Addendum No. 4

**Subject: SDP Contracts No. B-011 C, B-012 C, B-013 C and B-014 C of 2017/18
Major Renovation and Addition**

Location: Ethan Allen Elementary School

This Addendum dated June 22, 2020 shall modify and become part of the Contract Documents. Any items not mentioned herein, or affected by, shall remain strictly in accordance with the original document.

Drawing Title: PARTIAL 1ST FLOOR PLAN	
Drawing No.: SKA-02	
Reference RFI:	Reference Drawing: A-105, A-109
USA Project No.: 2018-080	
Drawn By: MW	Checked By: RH
Date: 06/22/20	Page: 1 of 1

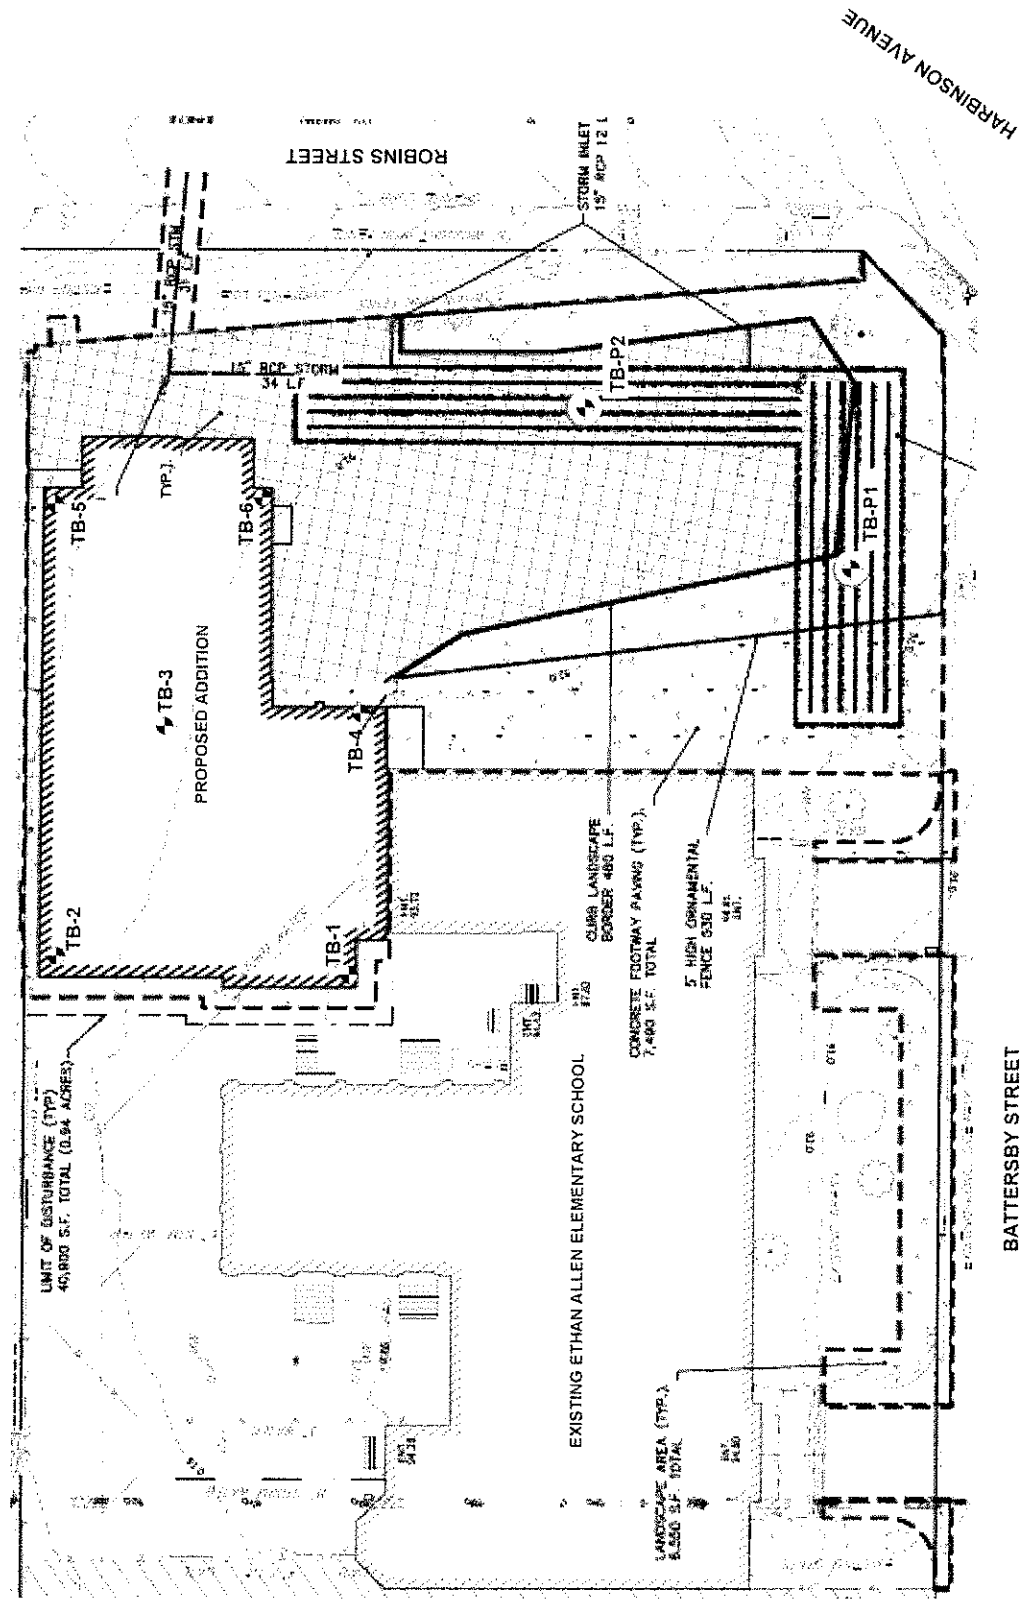
B. Drawing A-109 - First Floor Addition Plan - Area B: The door in the fire wall shall be identified as Door B101.

1. The door shall be revised to provide a leaf swinging in each direction. See attached SK-02: Partial First Floor Plan
2. Revised Hardware to include (2) Vertical Rods and Astragal.
